DOCUMENT 00903  
ADDENDUM NO 3

DATE: February 23, 2026

PROJECT NAME: River Bend Transit Facility Addition

**M1**

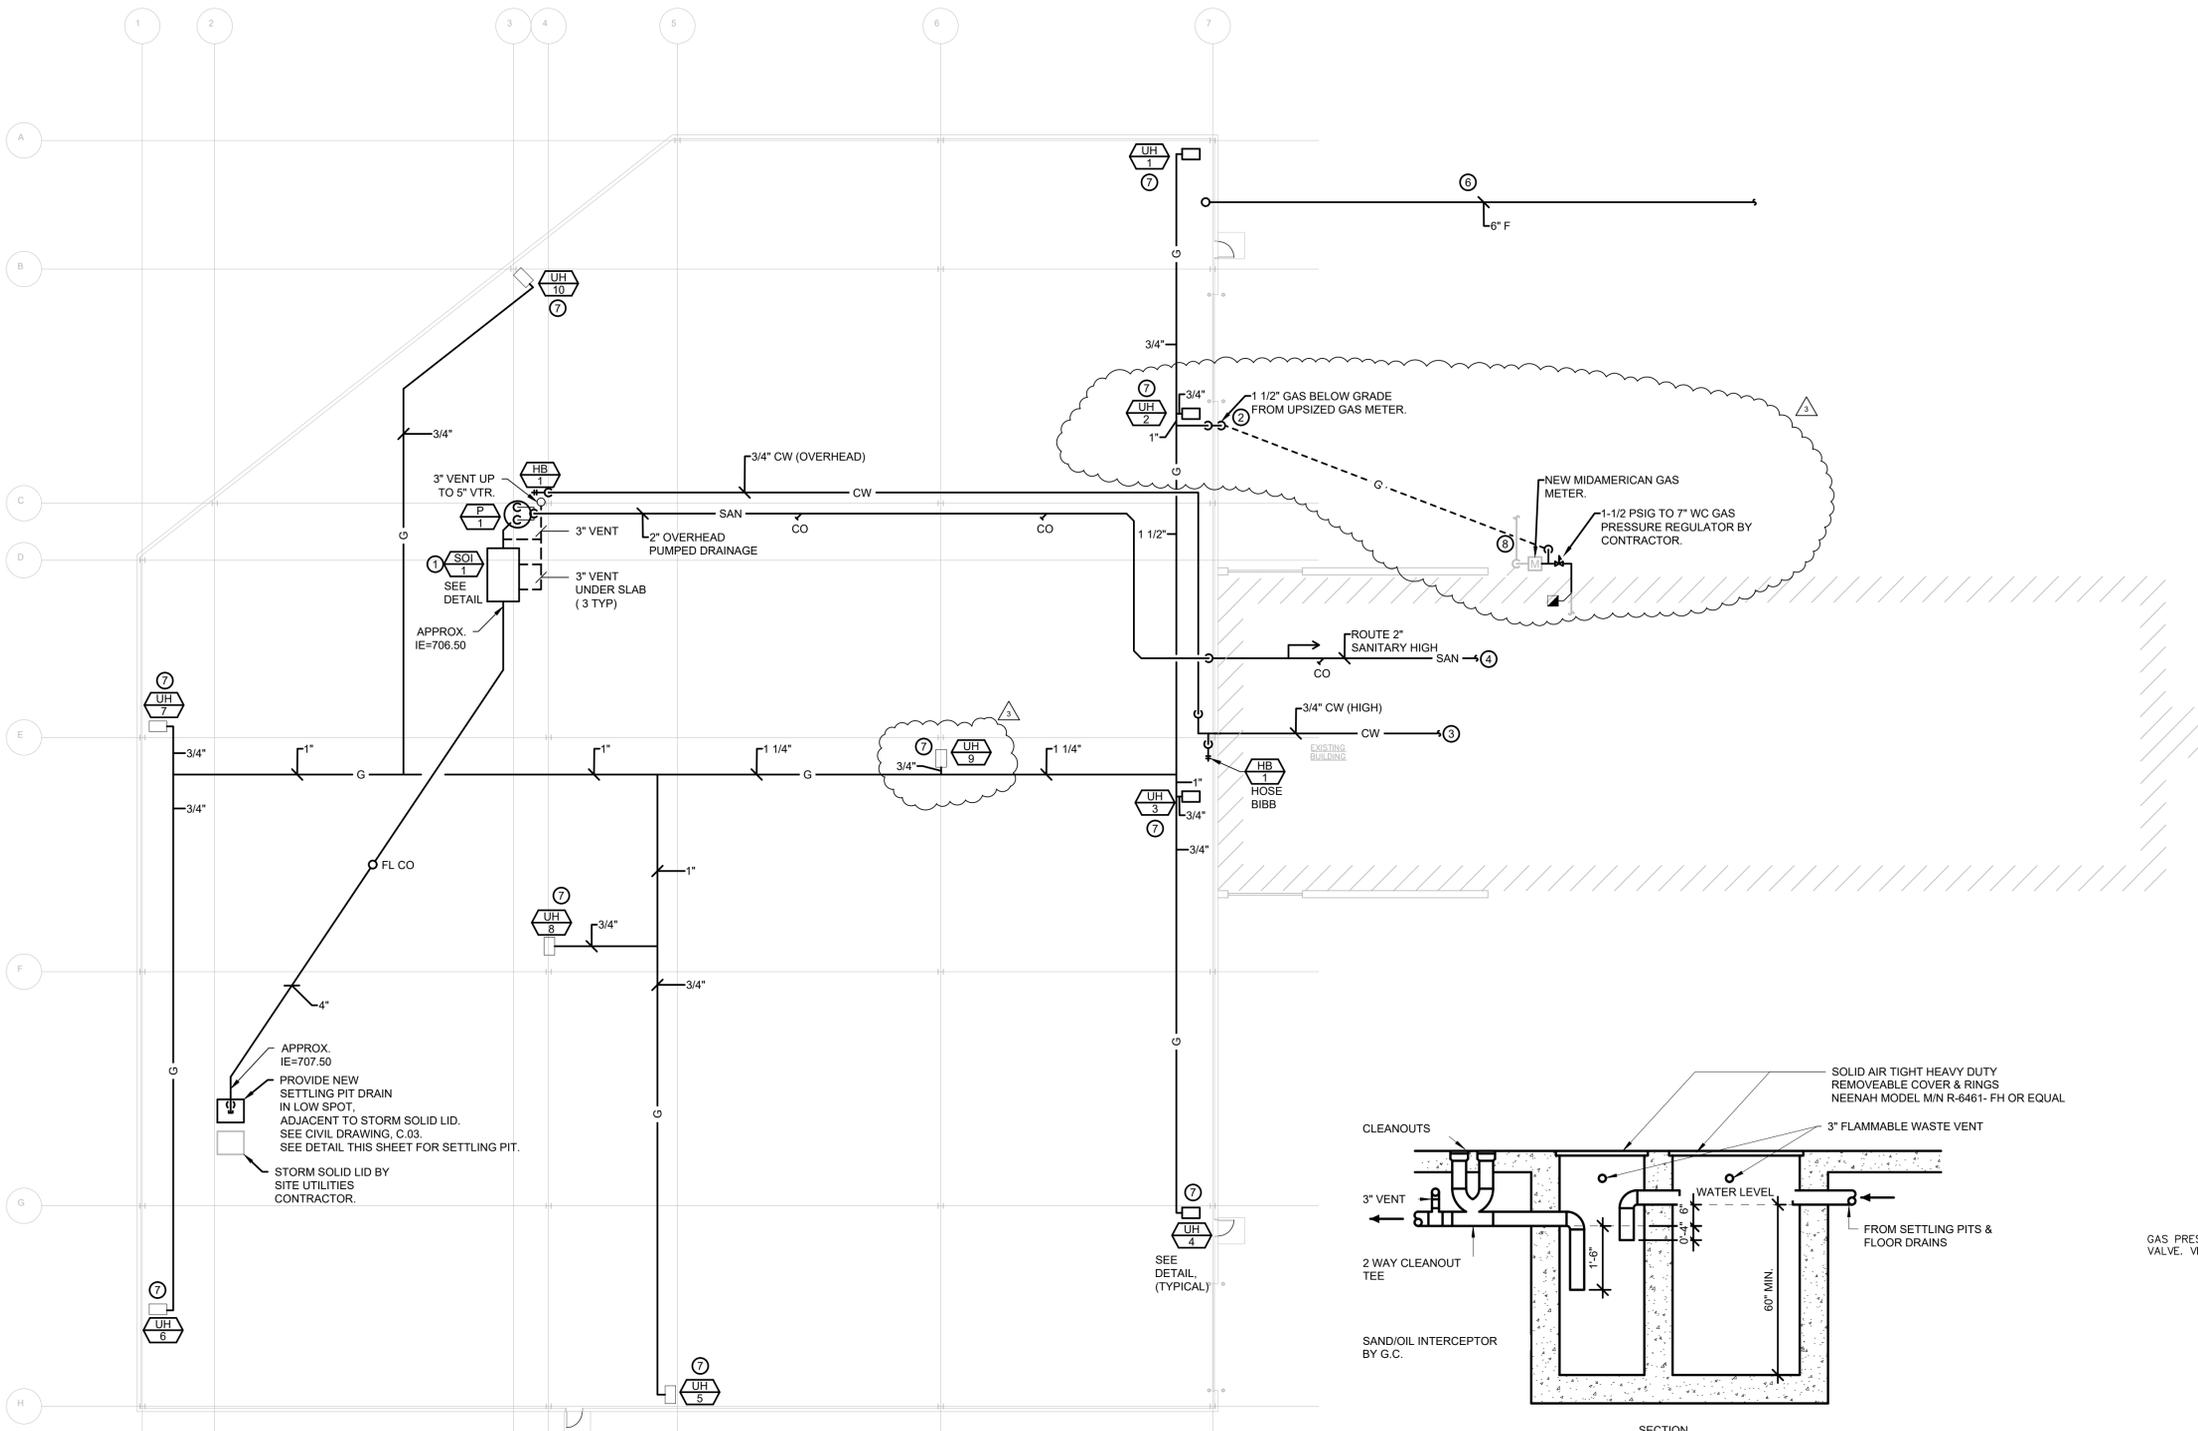
1. Sheet M1: Plumbing Plan: See revised sheet in its entirety.
  - a. Specific Mechanical Notes, **ADD** the following to Note #7, "Extend Class B vent pipe for power combustion exhaust up through the roof with roof termination cap per manufacturer's requirements. Seal exhaust vent system with high temperature rated sealant, RTV-106 or equal.
  - b. Specific Mechanical Note #7 also applies to unit heater, UH-9.
  - c. See changes to gas service and Specific Mechanical Note #8.

- EXTEND CLASS B VENT PIPE FOR POWER COMBUSTION EXHAUST UP THROUGH THE ROOF WITH ROOF TERMINATION CAP PER MANUFACTURER'S REQUIREMENTS. SEAL EXHAUST VENT SYSTEM WITH HIGH TEMPERATURE RATED SEALANT, RTV-106 OR EQUAL.

C.03

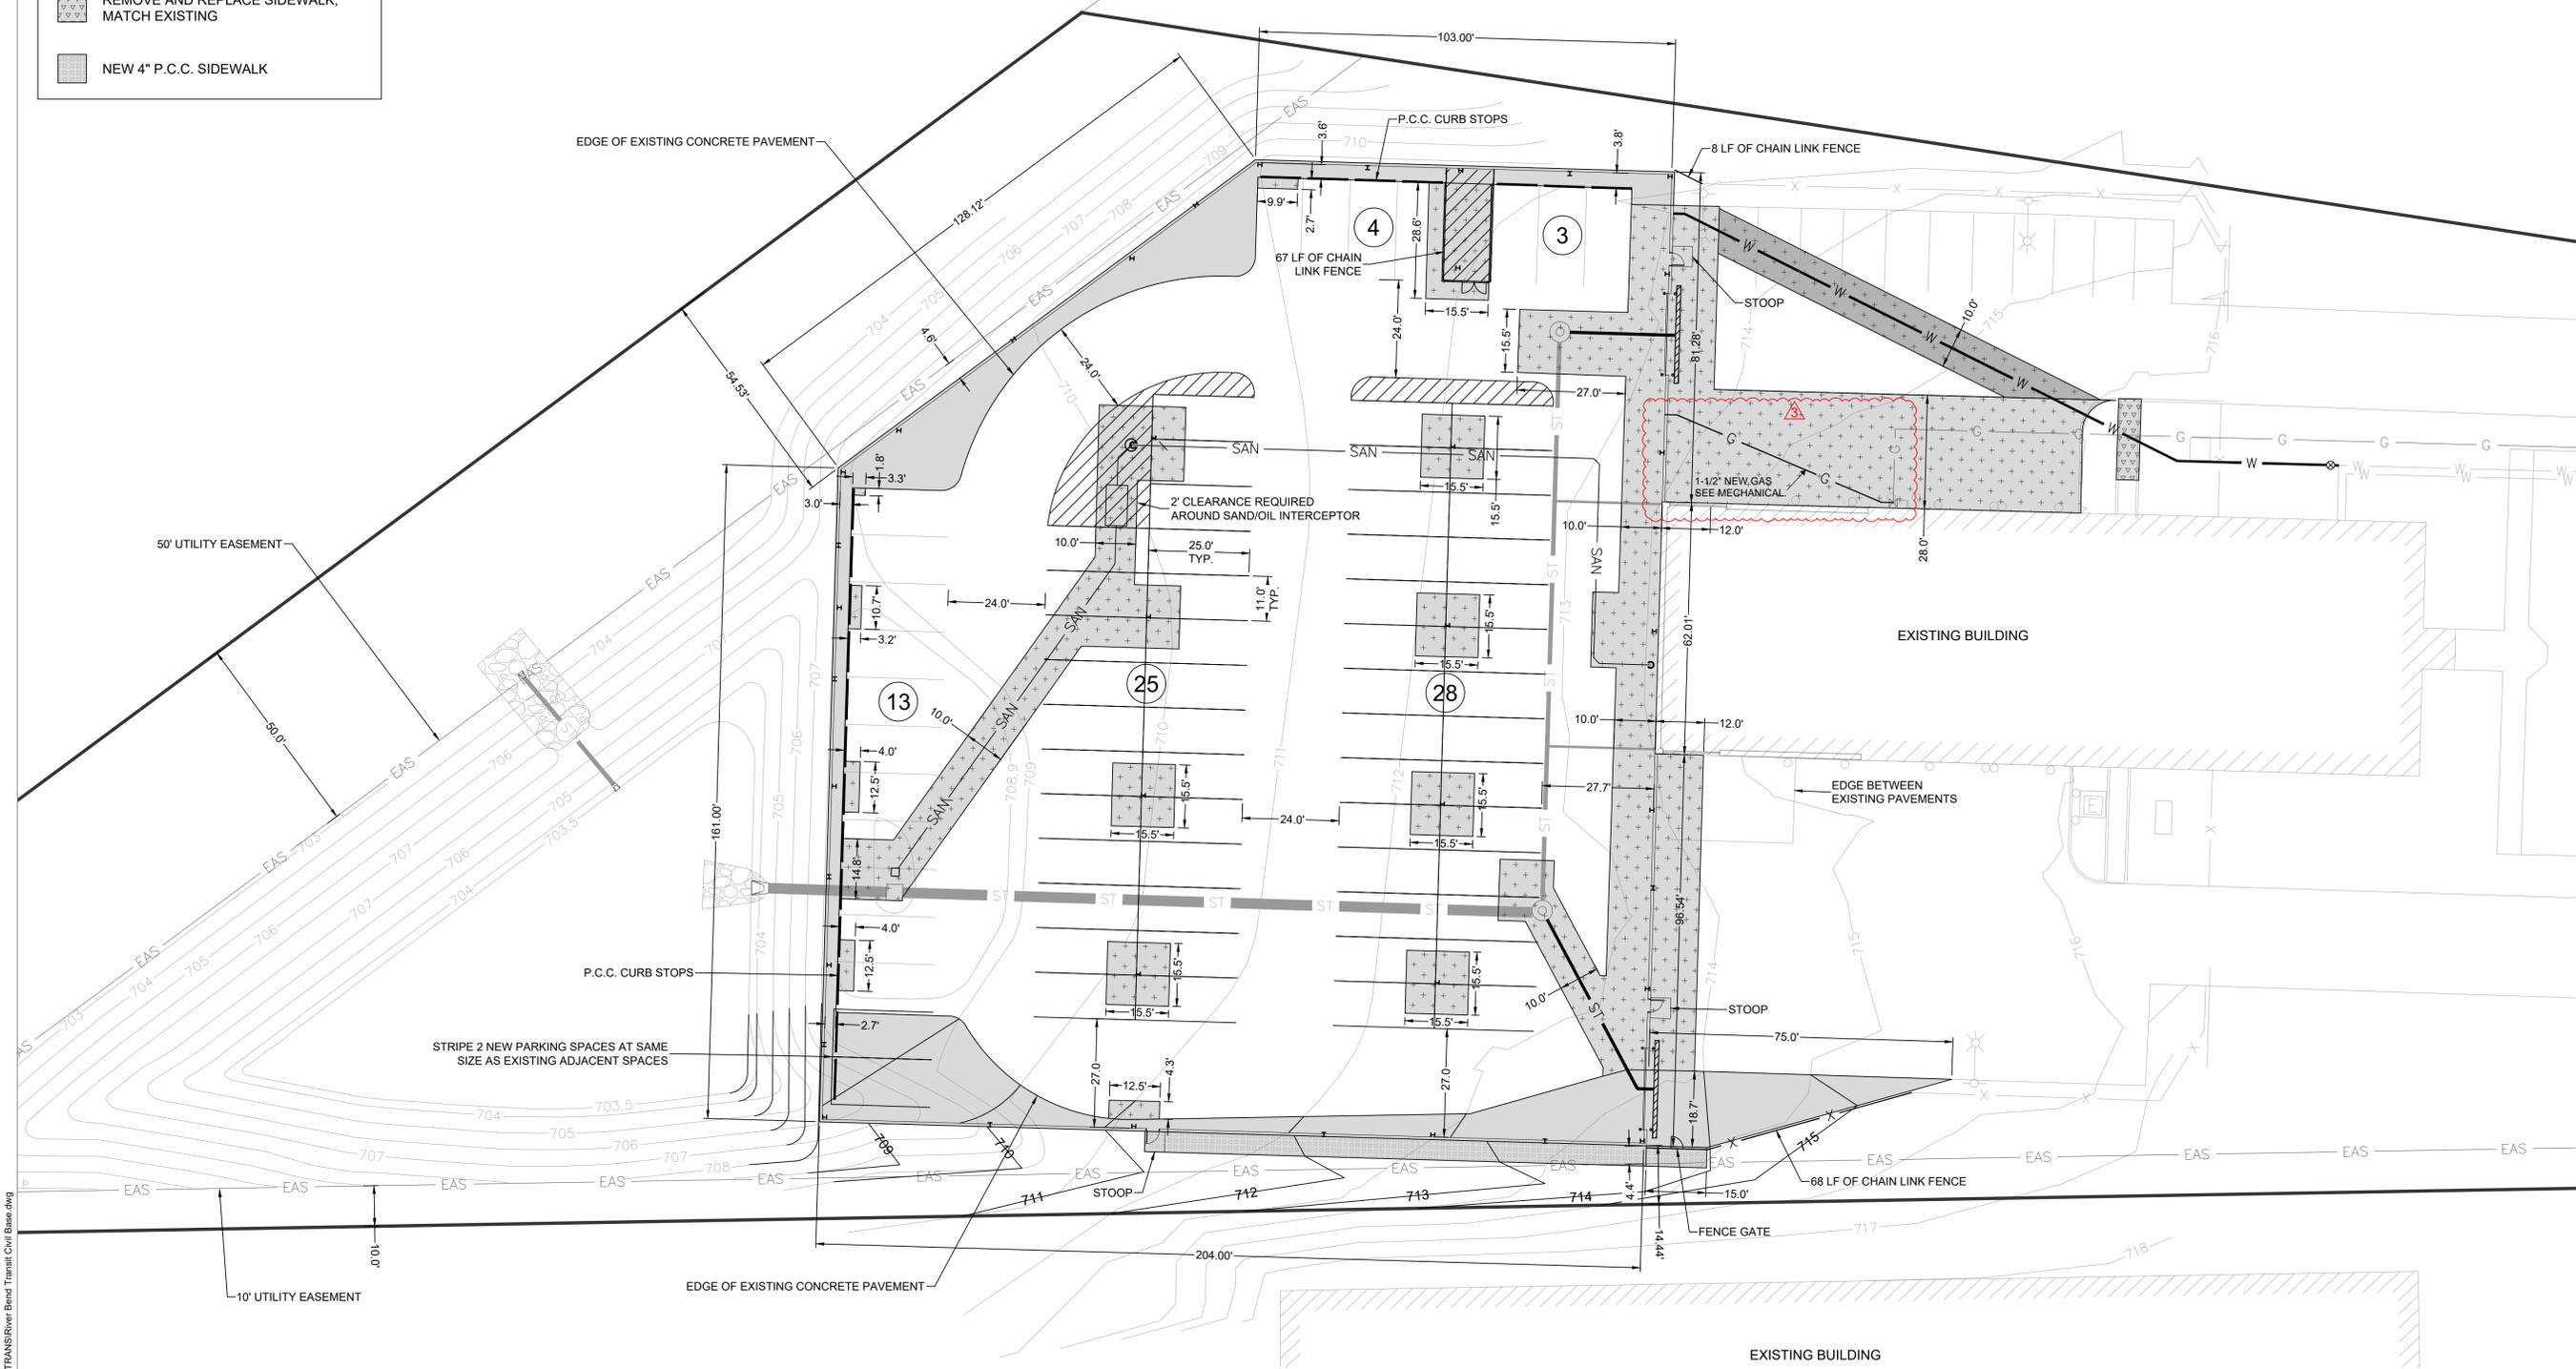
1. **REVISE** Sheets C.05, C04, C05, C07, and C09 - See attached.

**EXTERIOR FOOTING PLAN**  
NO SCALE

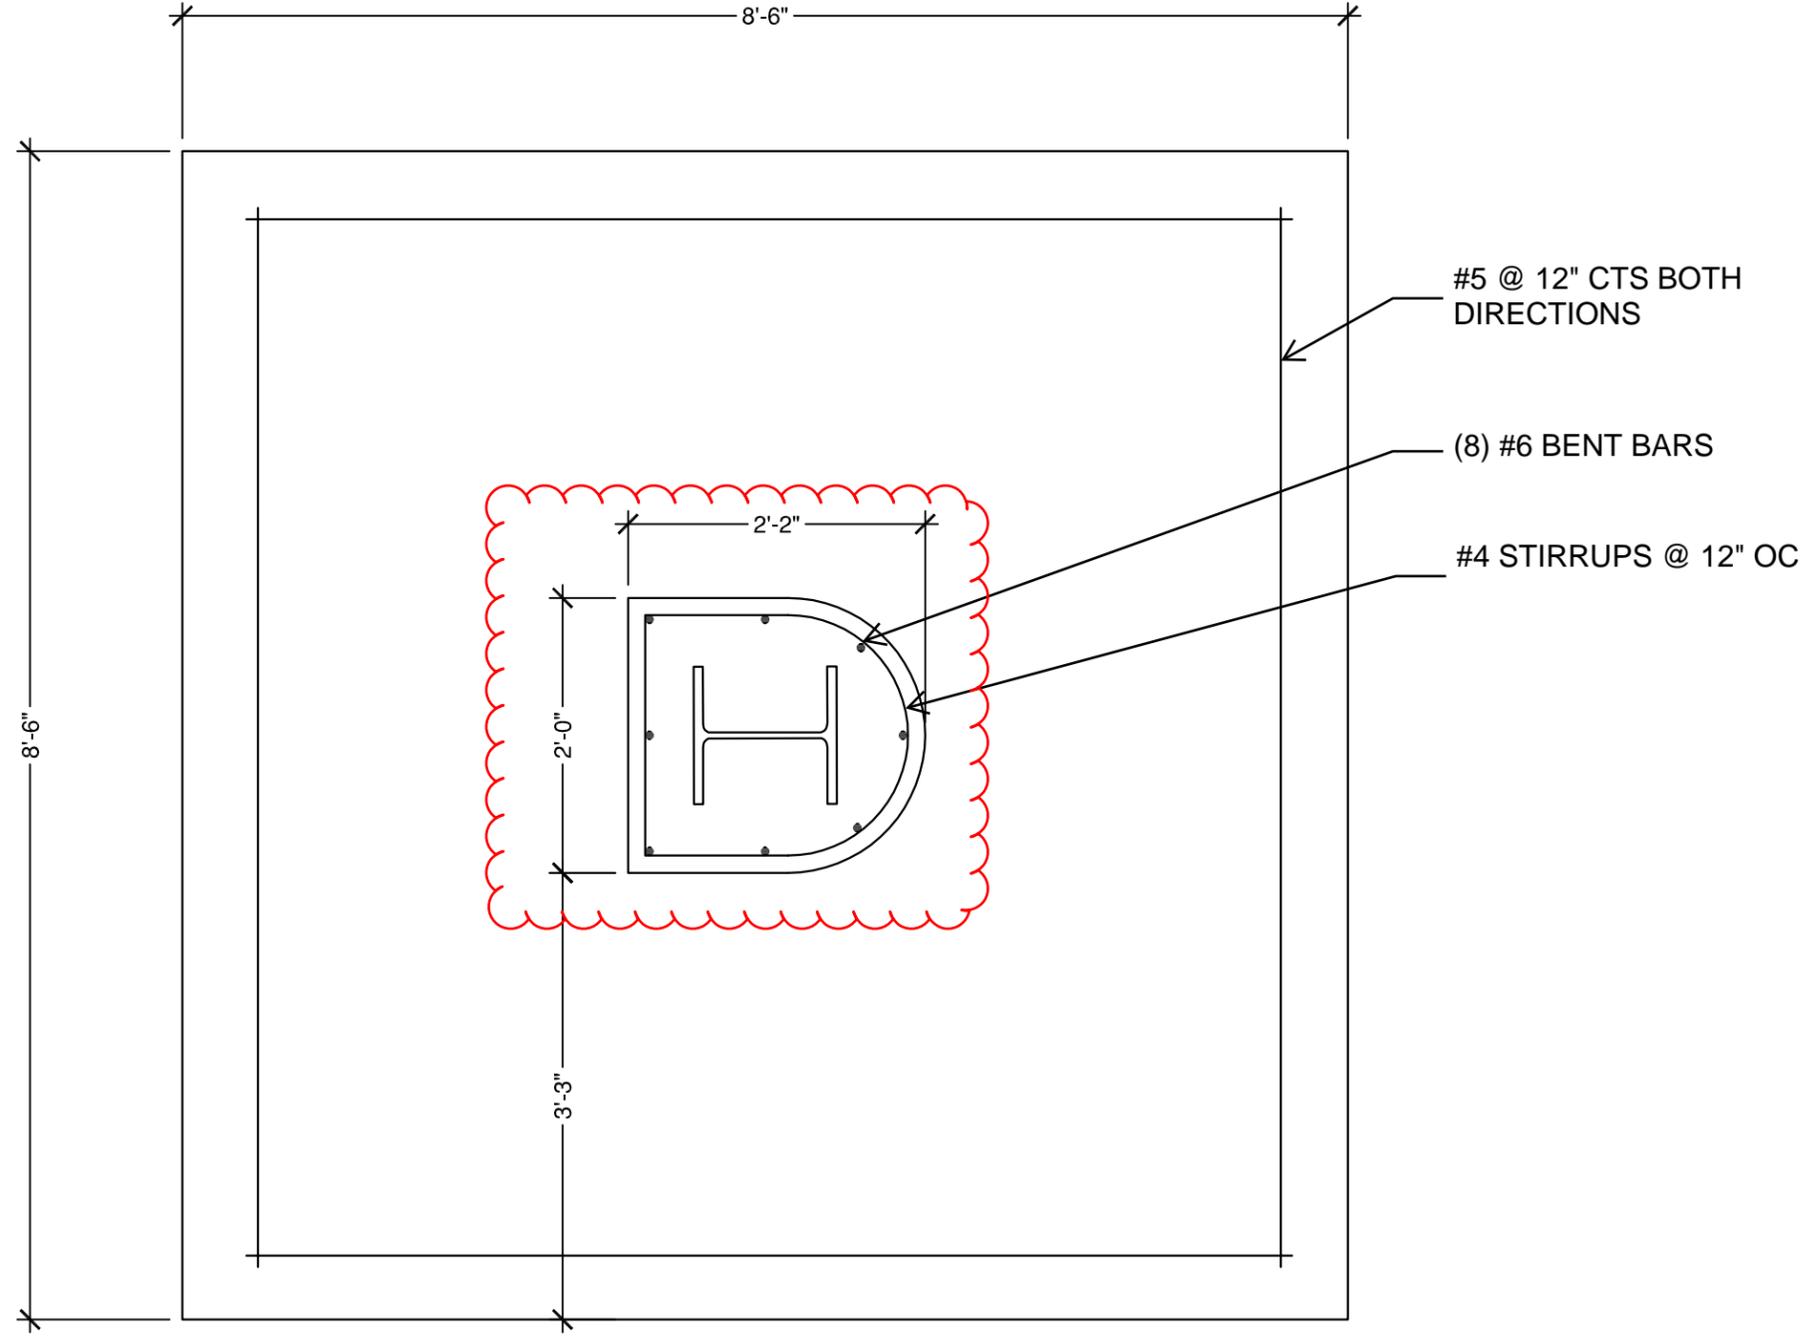
1. Sheet S2 – Structural Details
  - a. Detail 1 – **REVISE** shape of pier – See attached sheet SD-1
  - b. Detail 7 – **REVISE** shape of pier to match pier shown on attached SD-1
